Release Note DS-4CU **VA1** v6.1.10.13

(This version is only compatible with the new HW version – VA1)

Device Hardware Version

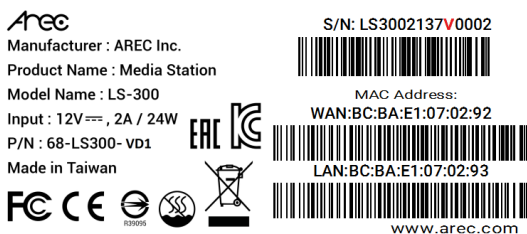
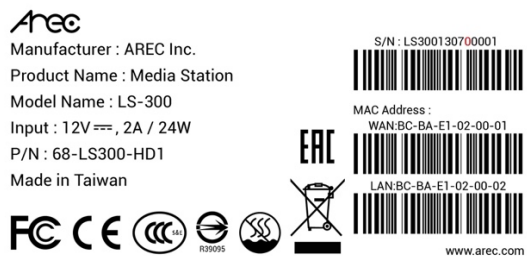
1. Please find your device serial number (S/N), it can be found either on the label or on the web Administration page.

2. Check the 10th digit of the S/N. If it is “V”, then the device has the new hardware. If it is “0”, it has the original hardware and is not compatible with the firmware series described in this release note.
